CSP 26-003KB (BP022) – ADDENDUM No.02
Gym Renovations and Additions

ADDENDUM

Addendum Number Two (02)
TO PLANS AND SPECIFICATIONS FOR
CSP 26-003KB BP022 Gym Renovations
Fort Bend ISD
STANTEC Project Nos.: 214001246

October 21, 2025

C1 A320 PLAN DETAIL

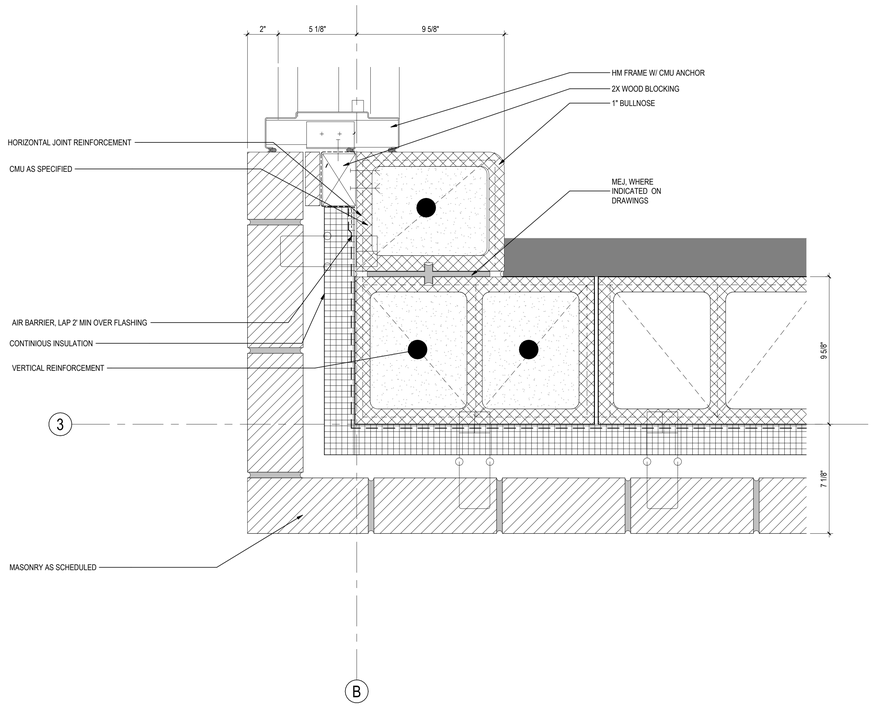
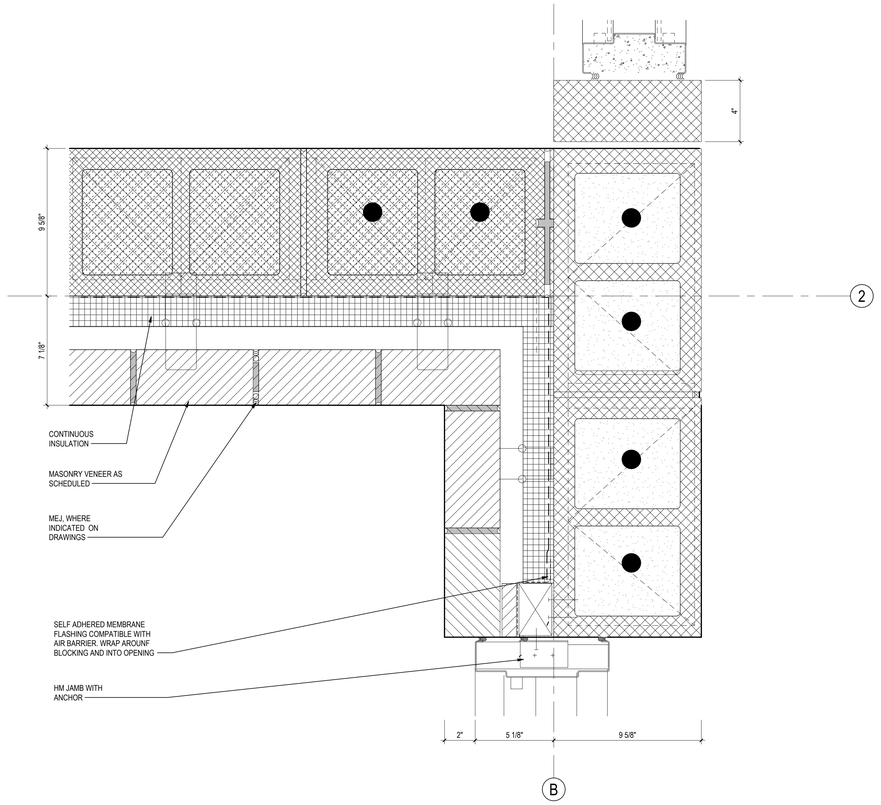
f. **A320 – HGES – EXTERIOR PLAN DETAILS**
   i. ADDED SHEET IN ITS ENTIRETY
g. **A322-HGES – EXTERIOR SECTION DETAILS**
   i. ADDED SHEET IN ITS ENTIRETY

Project No.	Scale
214001246	As indicated
Revision	Drawing No.
2	E301-HGES

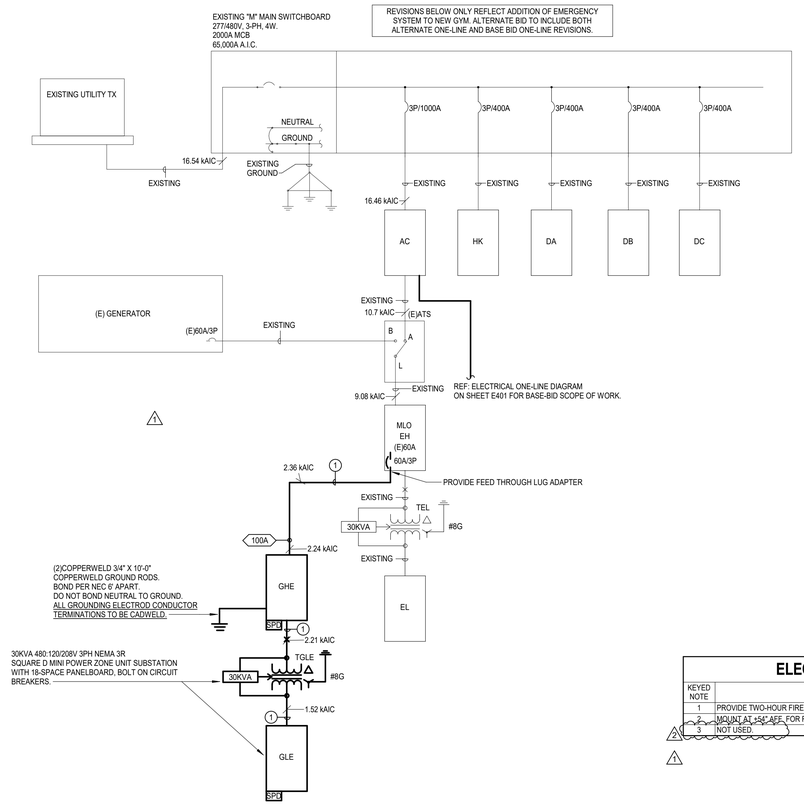
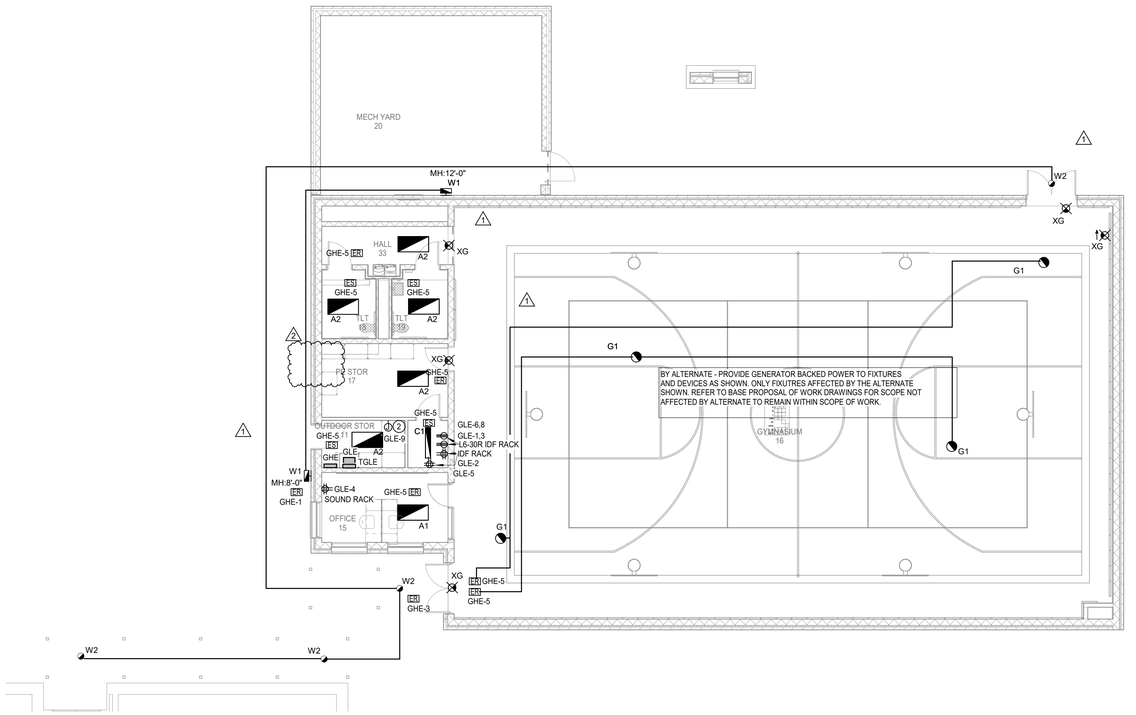
i. REMOVED PLAN NOTE 3 AND ASSOCIATED MOTORIZED DAMPER LOCATION.
ii. ADDED BLOCK NOTE FOR MOTORIZED DAMPER POWER COORDINATION.

Drawing No. **G102 - PES**

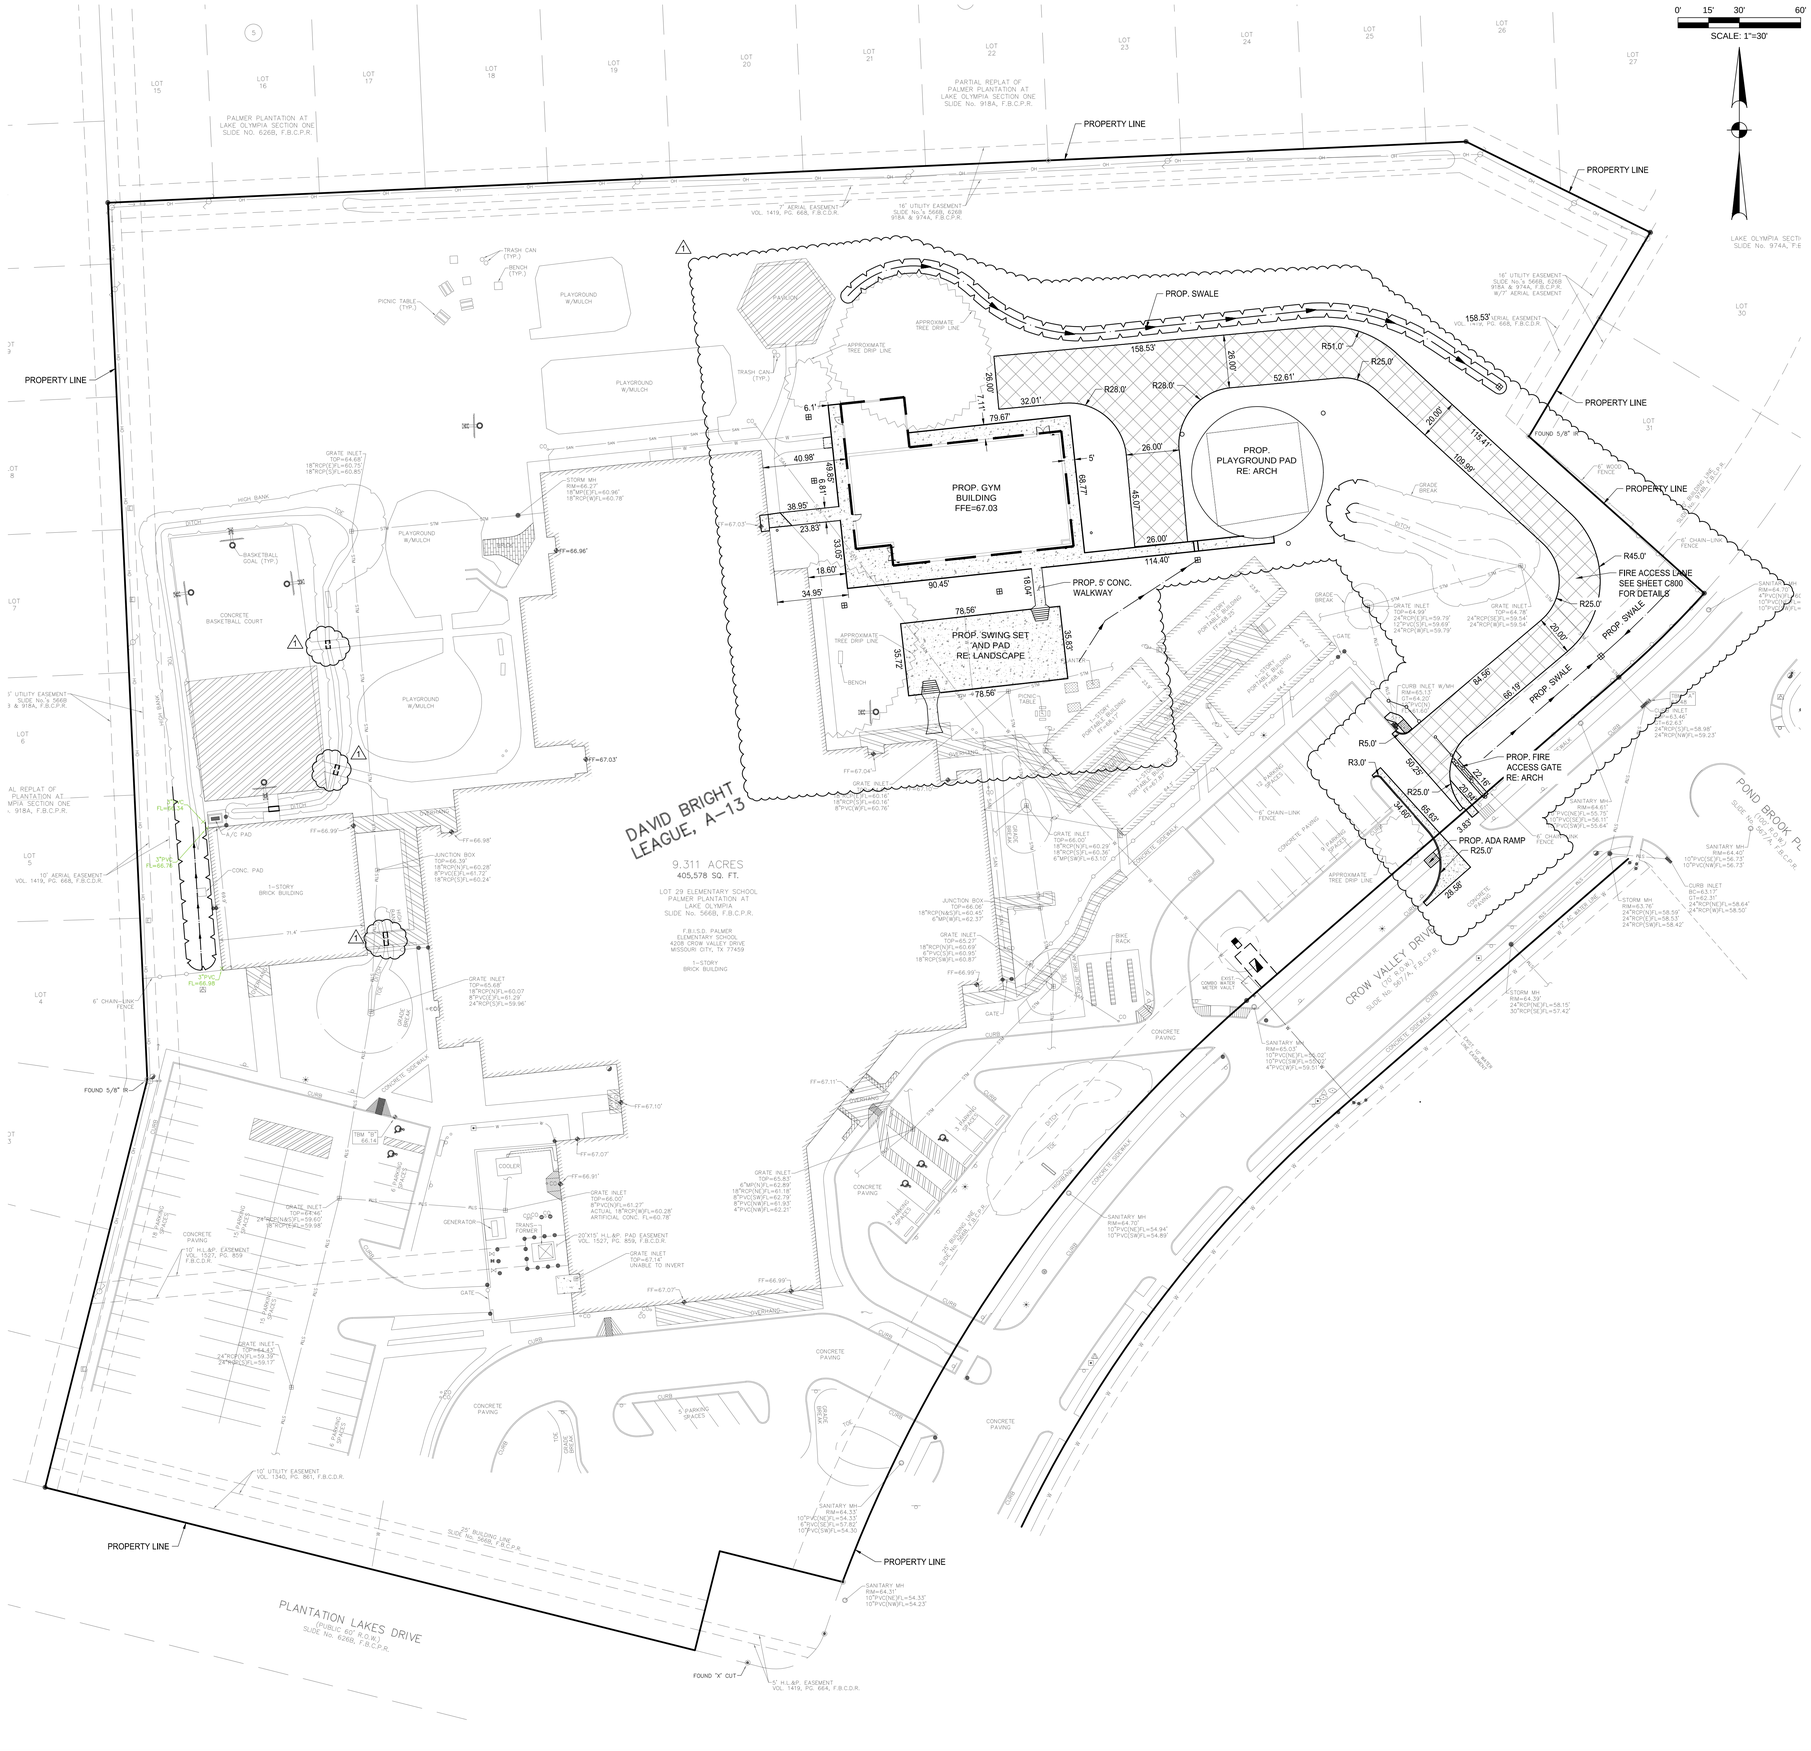
a. **G102 – PGES – CODE REVIEW AND LIFE SAFETY PLAN - GYMNASIUM**
   i. ADDED DETAIL LINE TO CLARIFY EXTENT OF FIRE RATING FOR EXTERIOR WALLS
b. **AS001 – PES – WALKWAY COVER DETAILS**
   i. ADDED DIMENSIONS TO EXISTING WALKWAY COVER SO THAT THE INLCUSION OF PAINTING THE ENTIRETY OF THE WALKWAY COVER COULD BE INCLUDED IN COST OF WORK

Project No. 214001246	Scale 1/4" = 1'-0"
Revision 1	Drawing No. A103 - PES

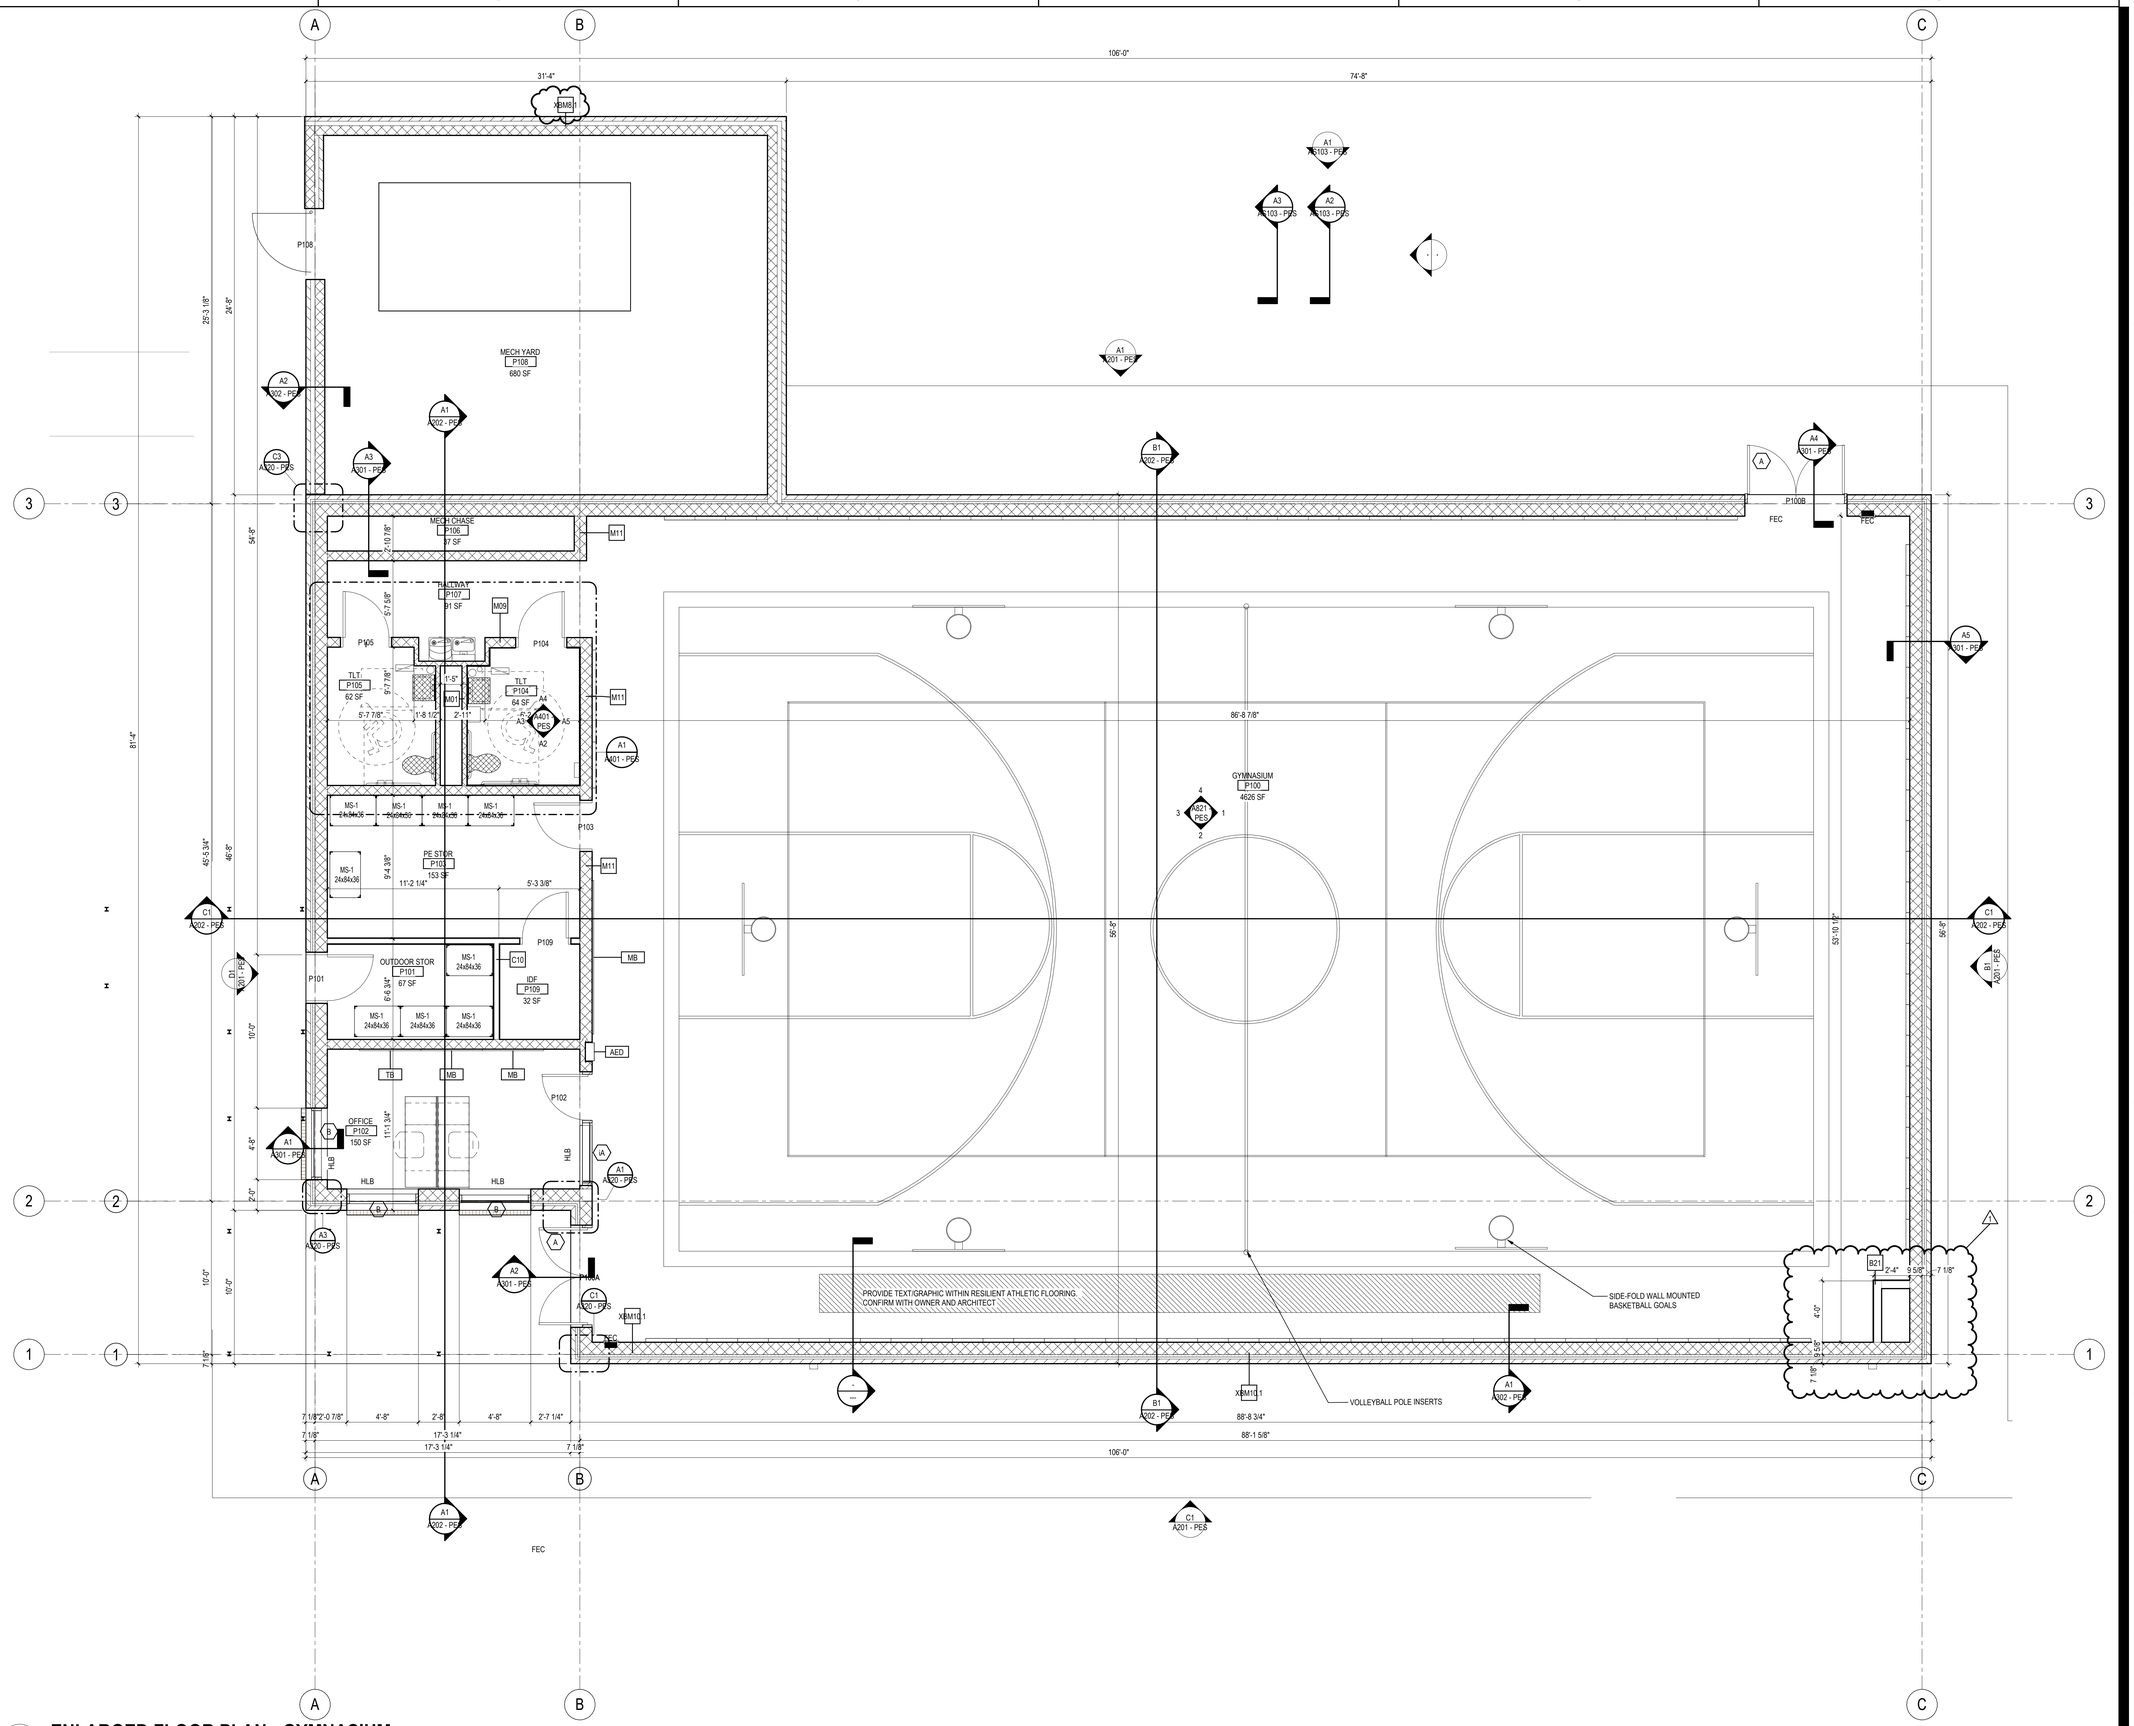
c. **AS101 – PES ARCHITECTURAL SITE PLAN**
   i. ADDED CALLOUT CLARIFYING EXTENT OF EXISTING WALKWAY COVER
d. **AS103 – PES – MOCK-UP WALL**
   i. ADDED SECTION AND DETAILING OF MOCK-UP WALL
e. **A320 – PES – EXTERIOR PLAN DETAILS**
   i. MODIFIED PLAN DETAILS FOR CLARITY
f. **A322-PES – EXTERIOR SECTION DETAILS**
   i. ADDED SHEET IN ITS ENTIRETY
g. **A323 – PES – EXTERIOR PLAN DETAILS**
   i. ADDED SHEET IN ITS ENTIRETY
h. **A501 – HGES – FRAME ELEVATIONS & DOOR SCHEDULE**
   i. ADDED CLARIFYING DETAILS TO FRAME ELEVATIONS
   ii. RECTIFIED EXTERIOR ALUMINUM FRAME SIZING FOR FRAME TYPE B & C TO 2 ½" X 5"

2 **ELECTRICAL ONE-LINE DIAGRAM - ALTERNATE**
Scale: N.T.S.

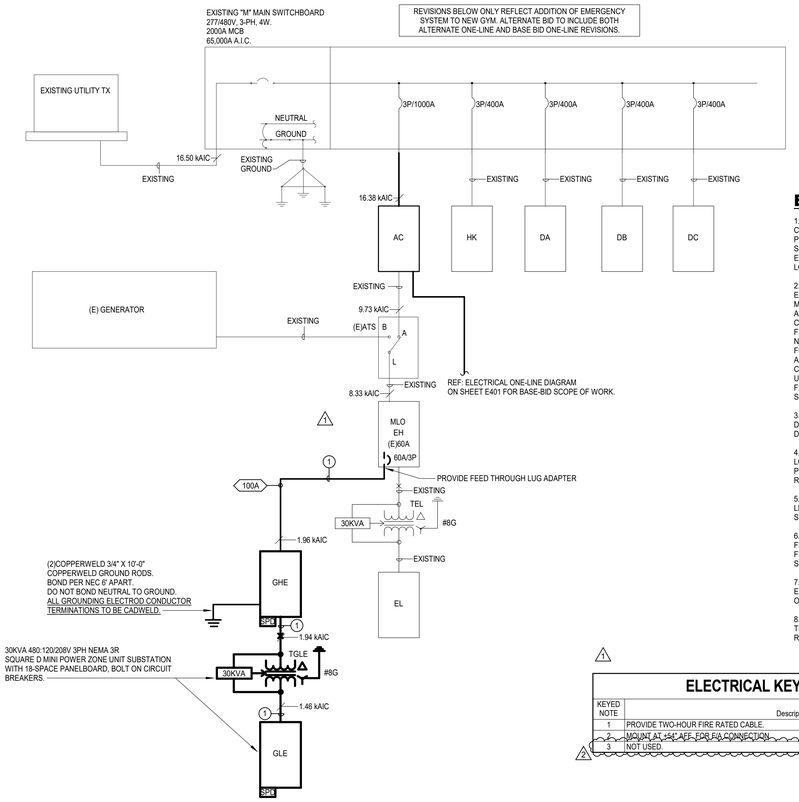
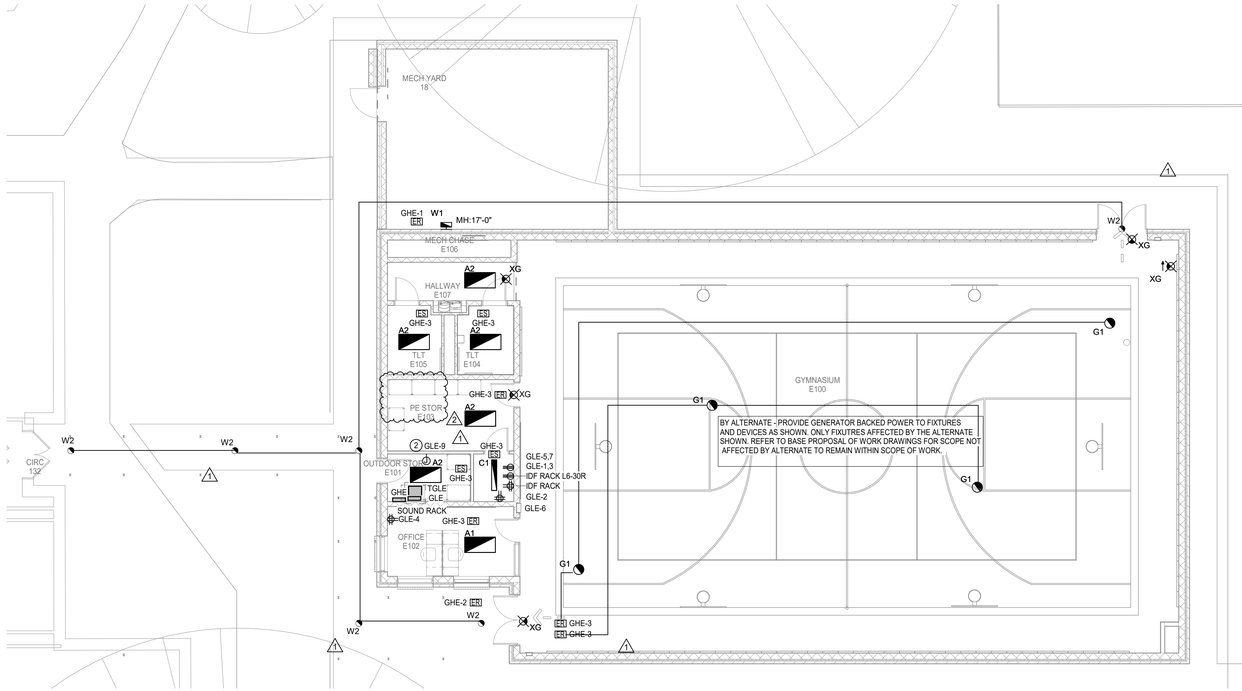
i. REMOVED PLAN NOTE 3 AND ASSOCIATED MOTORIZED DAMPER LOCATION.

ii. ADDED BLOCK NOTE FOR MOTORIZED DAMPER POWER COORDINATION.
